**SUBJECT:** Alteration to the U.S. Bank Plaza Building at 1 South Pinckney Street

TO: Urban Design Commission  
FROM: Kitty Rankin, Preservation Planner  
SUBJECT: **U. S. Bank Building, 1 S. Pinckney Street**

US BANK PLAZA  
UDC Submission

STREET / PROPOSED

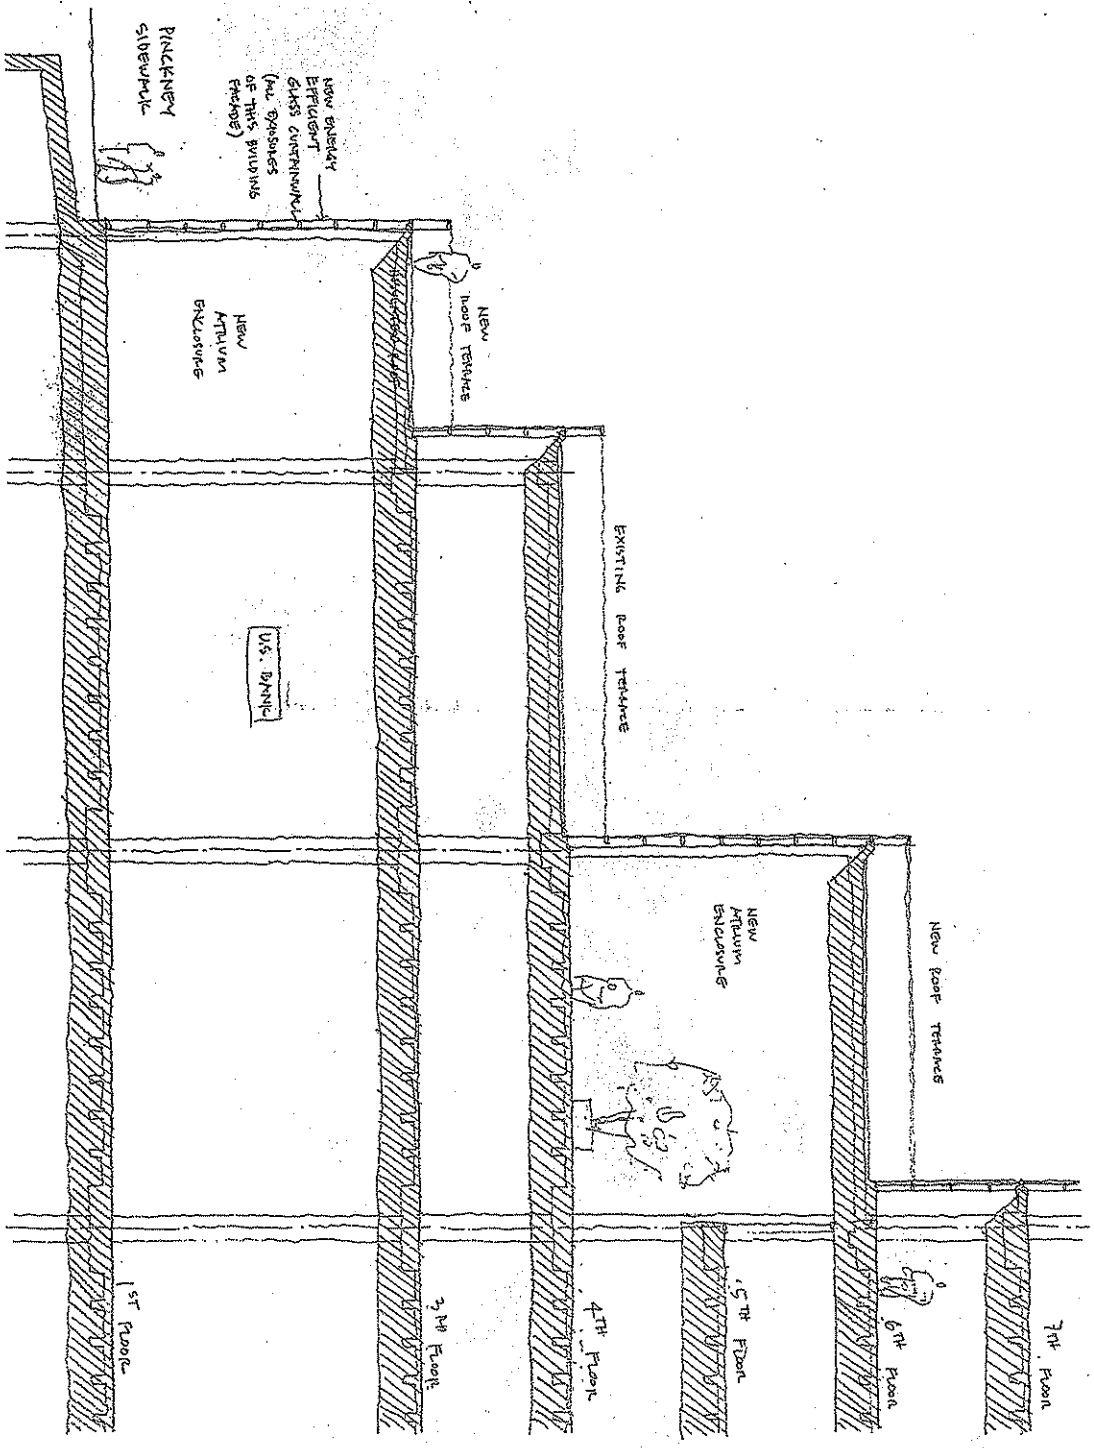
- Reconstruction of the sloped atrium area to address significant solar heat gain issues. The sloped atrium areas would be reconstructed with vertical glass walls which maintains a 2-story volume on the main floor levels of the atria and creates landscaped roof terraces on the third and sixth floors.

- Construction of a building addition of approximately 15,000 square feet of rentable area which occurs as a result of the removal of the secondary atrium on the fourth floor and the construction of a six-story addition to the Pinckney Street side of the building, set well back from the existing front facade.

BUILDING SECTION WITH PROPOSED  
ATRIUM ENCLOSURE MODIFICATIONS

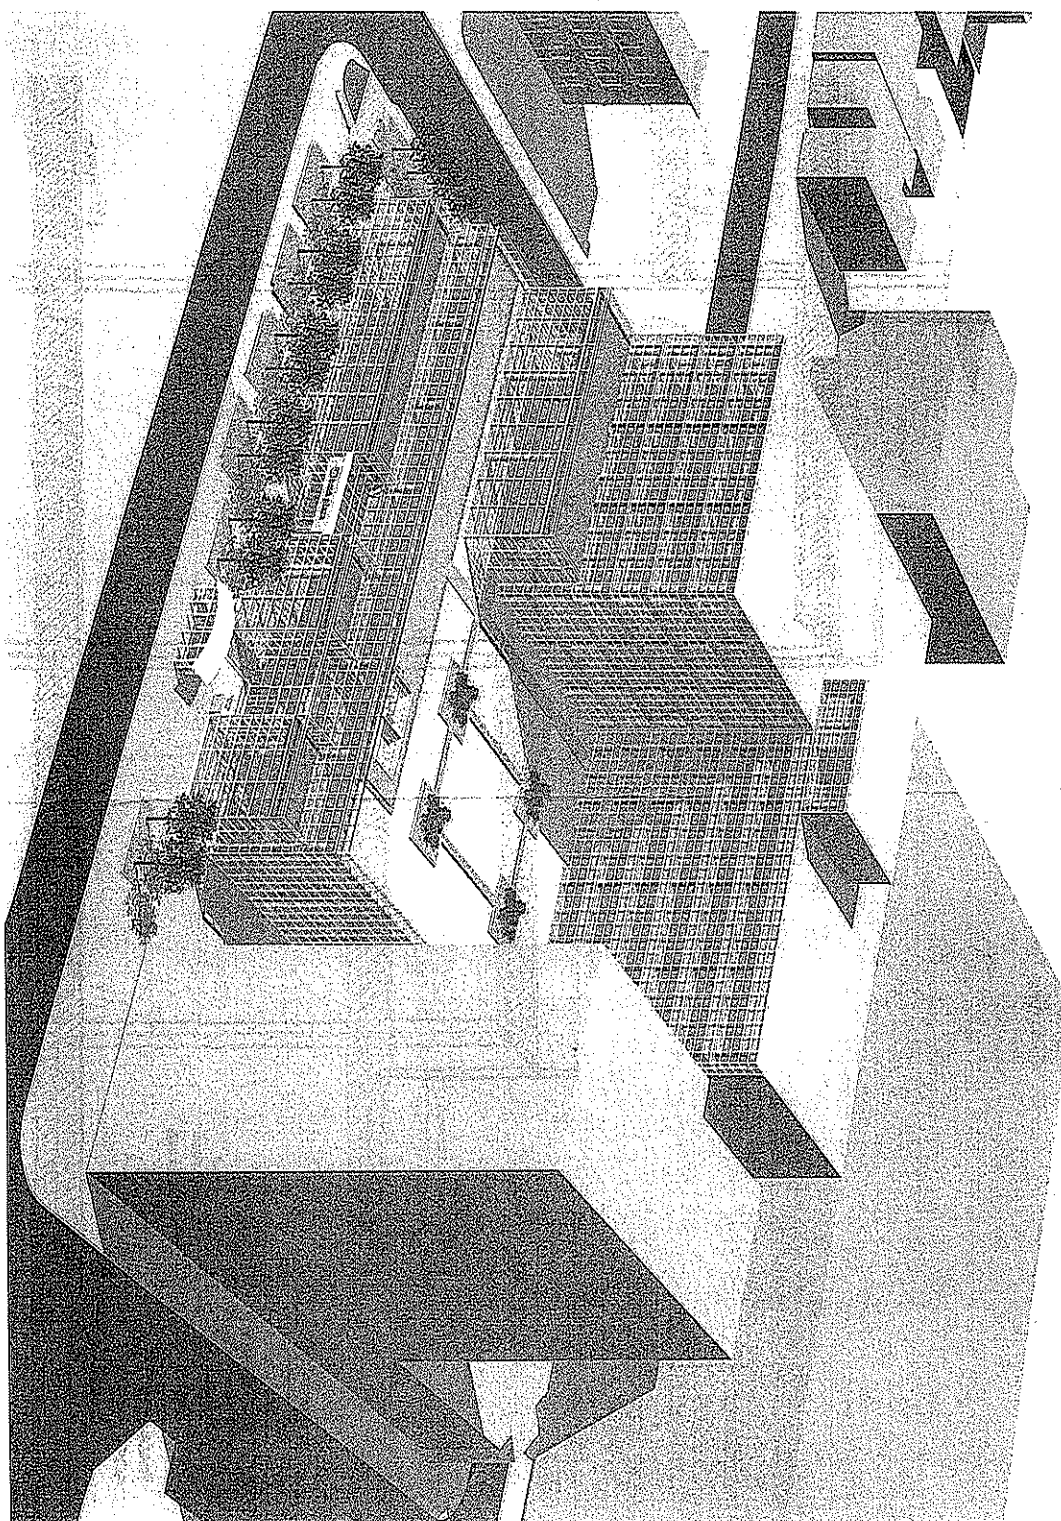
The First Wisconsin Plaza represents a similar scenario. Two of the distinctive features of the building is the large slanted-roofed atrium spaces at the front of the building and the window-wall design. The building was designed as an experiment in creating large greenhouse-type space as a public indoor plaza, allowing for public use during the cold months. Unfortunately, the architects did not properly understand the implications of this large greenhouse space, and the result was that the solar gain has been staggering. Even during construction the architects had realized their mistake and urged the owners to use different materials on the front to alleviate the solar gain, but such changes were not undertaken. Subsequent attempts to deal with the issue have not solved the problems. In my opinion, we have another example of a building that well may be eligible to be a landmark, but whose inherent design is not functional. While the architects were attempting to conserve energy, they had actually created a building that does the opposite.

While the window-wall exterior can be retained it would be hard to retain the slanted roofs without changes to their appearance to make the interior functional. I recommend approval of the proposed changes.

NINTH FLOOR

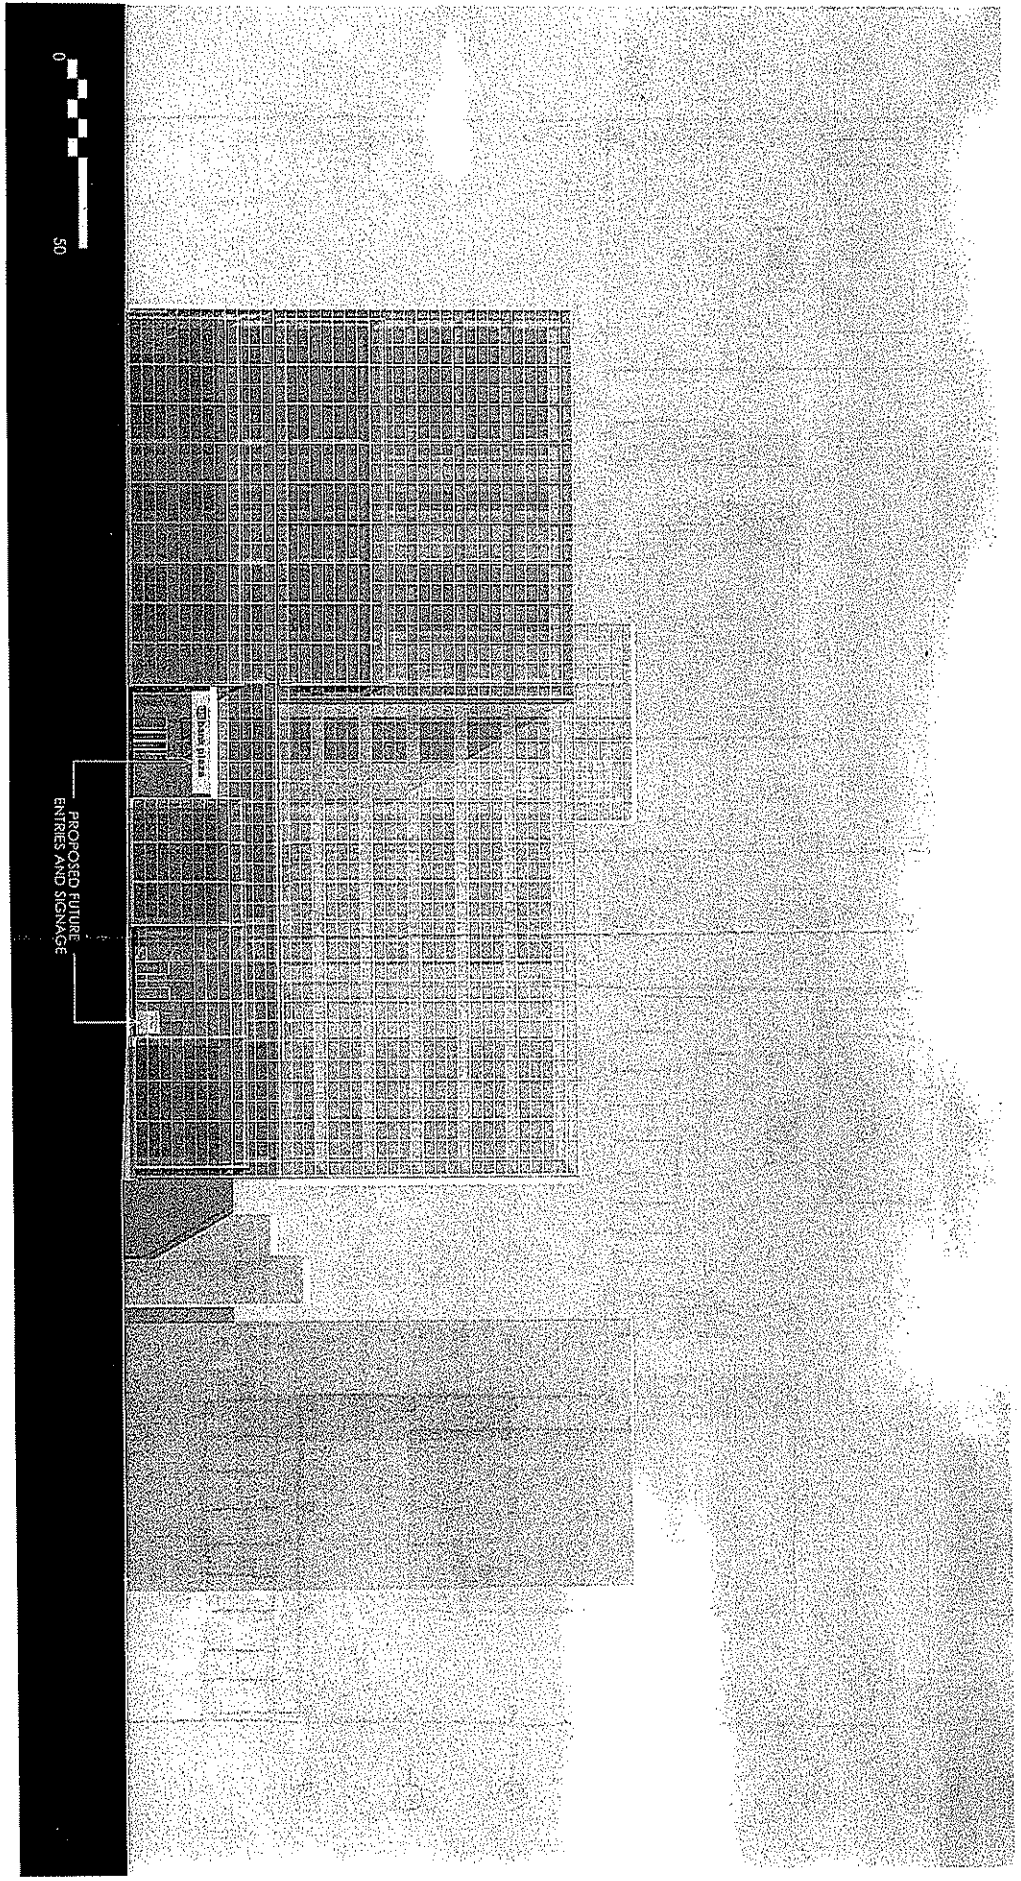
- In addition to the exterior improvements to the building, the new owners will also be replacing the existing chillers on the ninth floor with new equipment to be relocated on the ground floor of the building. This relocation allows this mechanical space to be recaptured and reused as office space.
